Memorandum

SUMMARY OF
P050023/S048, P950037/S100, P000009/S047, P070008/S028
Lumax 700/740 ICD, Lumax 600/640 CRT-D, PSW 1102.U Programmer Software
Biotronik, Inc.

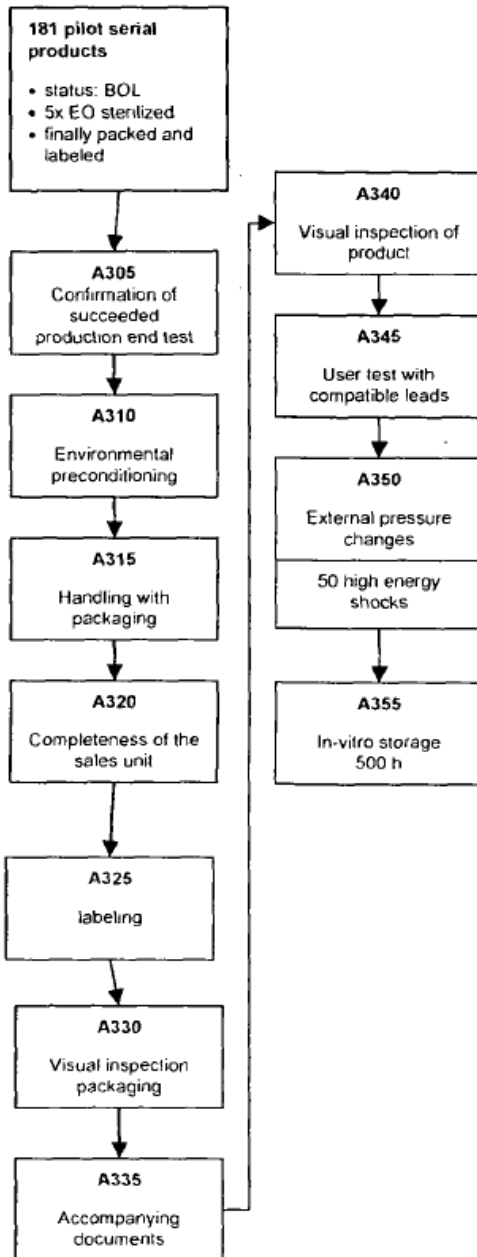
During the first round of verification and validation testing performed by the sponsor it was found that 2 devices failed the elevated pressure test. The problem was root caused to damage that occurred during the Environmental Preconditioning phase. It was determined that packaging did not provide enough cushioning for the devices. A revised package was established and the devices were subject to the Environmental Precondition phase 3 times. The preconditioning included the following:

After this was completed there was a visual inspection of the packaging, handling of packaging, completeness of sales unit, and final visual inspection of the product. The sponsor does not state if there were any electrical tests done after this routine. The original failure occurred towards the end of the validation flow chart which is provided below:

Since the testing that found the failure (A350 in the chart above) was done later in the validation process the stress of testing may have brought marginal devices to failure. The retested devices may have exhibited the same failure. The retested devices only required visual inspection. It seems that the full validation cycle should have been completed on the repackaged devices to ensure that if the same device failure occurred it would be caught by testing.

The Environmental Pre-Conditioning test is the third test in their packaging test protocol. They reevaluated the packing material and placed the sterile blister pack between the labeling packet and the sterile cover. This provides additional cushioning of the device. The sponsor conducted the pre-conditioning tests an additional 3 times with the new

configuration and completed the rest of the protocol of testing. The testing was successful and all devices passed. The revalidation was performed with the same sample size as the original testing. The revalidation of the testing seems appropriate and the new method of packaging seems to be appropriate. There are no further concerns with this deficiency.
